HERBATA DATA CENTRE, NAAS - RESPONSE TO REQUEST FOR FURTHER INFORMATION ("RESPONSE TO RFI") FROM KILDARE COUNTY COUNCIL

ADDENDUM TO CHAPTER 1 INTRODUCTION AND NEED FOR EIAR

NI2615
01
June 2025

Figure 1.2: Amended Overall Proposed Site Plan (extract of now submitted drawing 22217-RKD-ZZ-ZZ-DR-A-1010-OVERALL PROPOSED SITE PLAN)

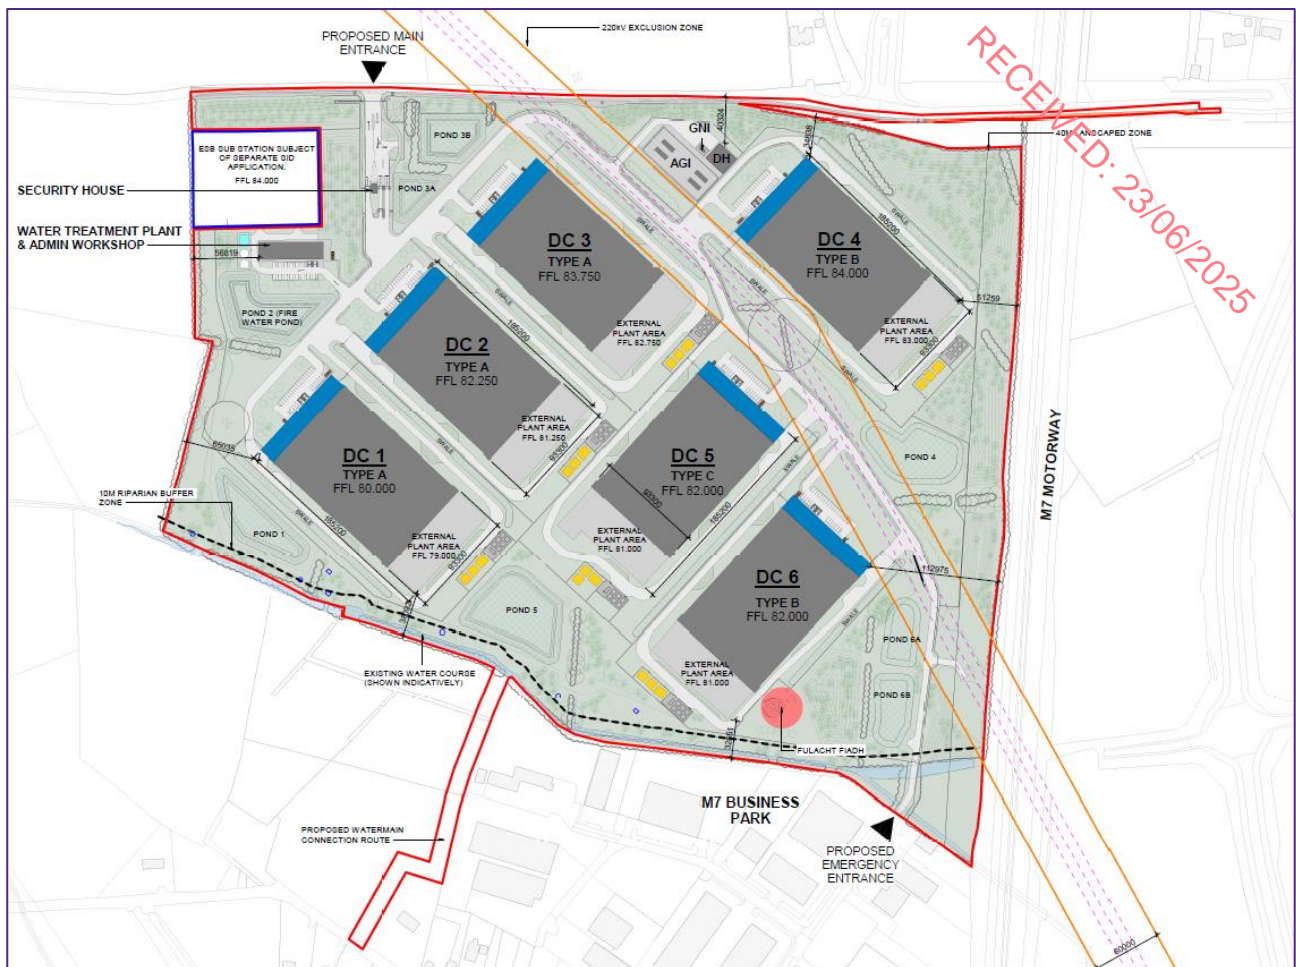
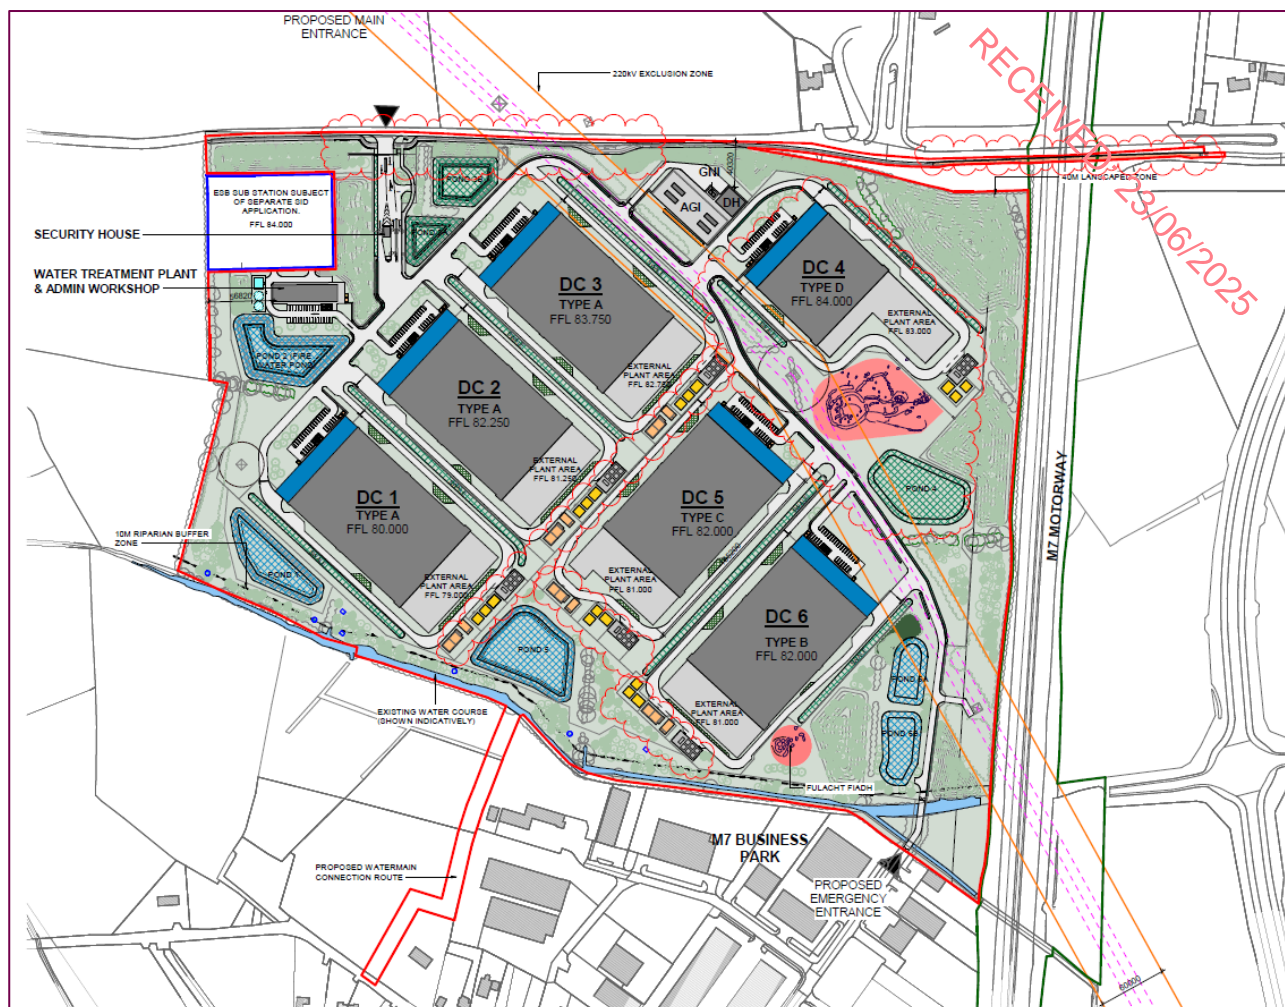
An amended design is proposed for Data Centre 4, primarily in respect of the arrangement of the proposed energy plant area (to the rear of the building) and subsequently, the overall plan of the building.

The amended design of Data Centre 4 is in response to the Kildare County Council RFI (Item 25) having considered the potential archaeological feature identified to the south east corner of the building; further detail and consideration of this is provided in the Addendum to Chapter 10 Cultural Heritage of the EIAR.

In order to accommodate the amended design of Data Centre 4 building, minor amendments to the layout of ancillary elements (such as security fencing, access road, drainage etc) which are within immediate vicinity of the building, are proposed. The component elements of Data Centre 4 (as summarised in Section 1.2 (a) above), the location within the overall site, building height, materials and finishes, remain unchanged.

For the purpose of comparison, Figures 1.1 and 1.2 below, illustrate the previously submitted site context plan and the amended, proposed site context plan respectively.

Figure 1.4: Amended Proposed Site Plan (extract of now submitted drawing 22217-RKD-ZZ-ZZ-DR-A-1012-PROPOSED SITE PLAN B)

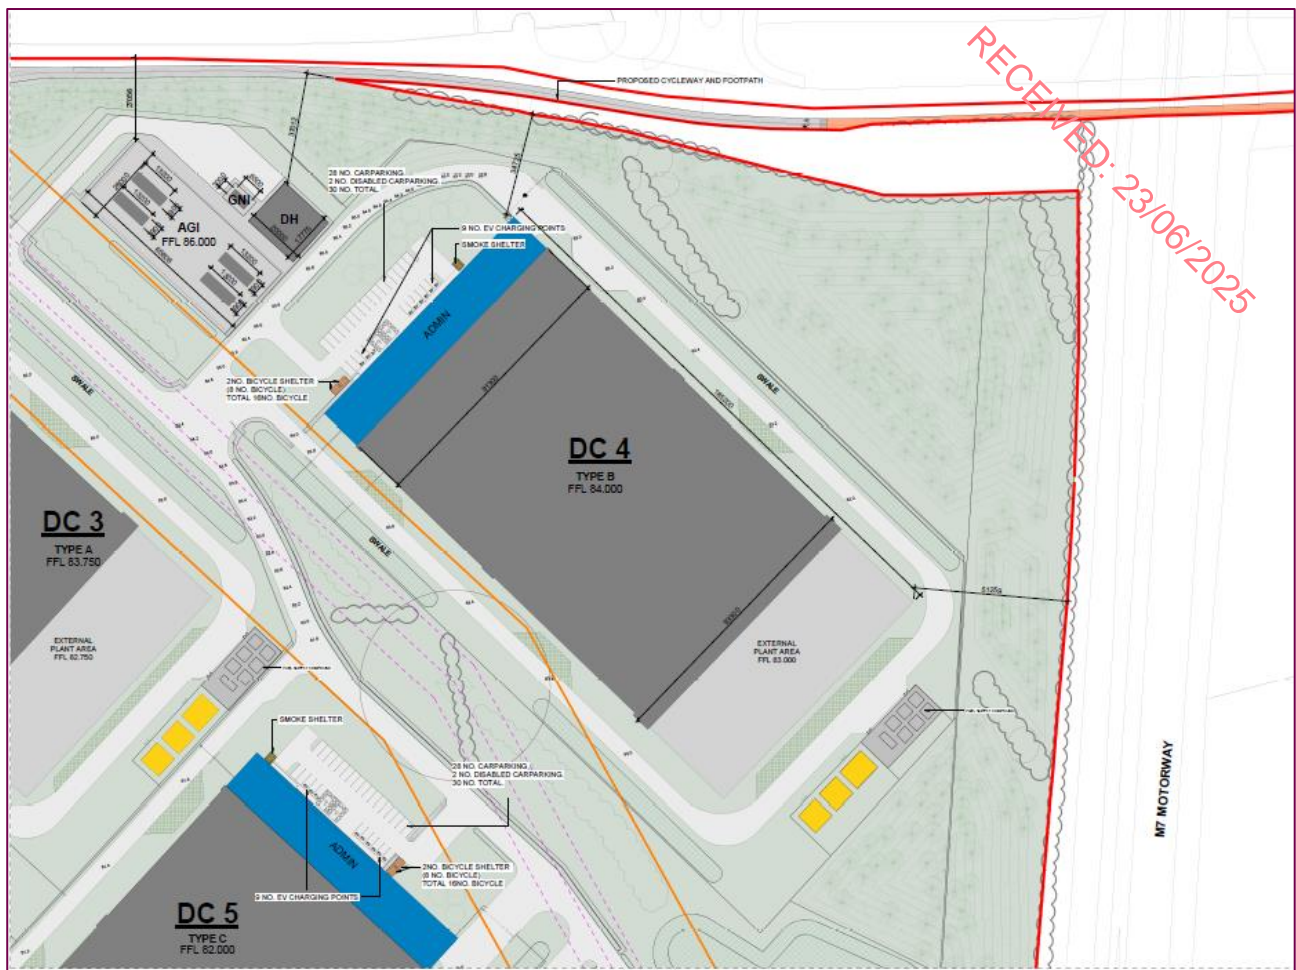
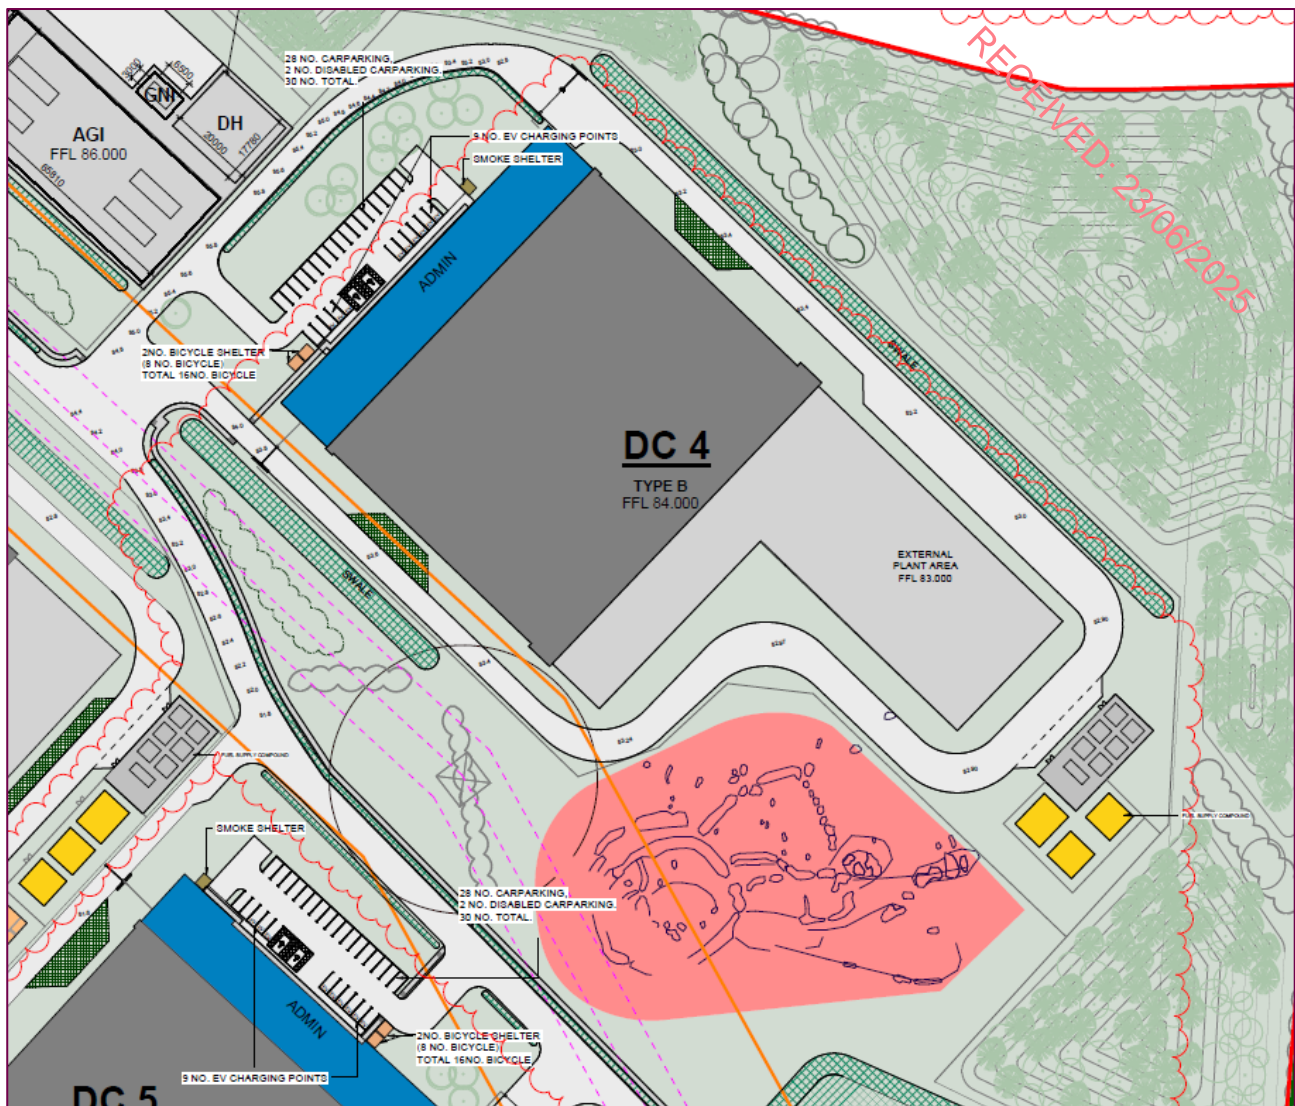
The external plant gantry and enclosed yard to the rear (encompassing the building energy infrastructure) of Data Centre 4 remains largely consistent with the description set out in the submitted EIAR however the arrangement of the energy infrastructure has been altered to reflect the amended building design.

For the purpose of comparison, Figures 1.3 and 1.4 below, illustrate the previously submitted layout detail for Data Centre 4 and (amended) proposed layout detail for Data Centre 4 respectively.
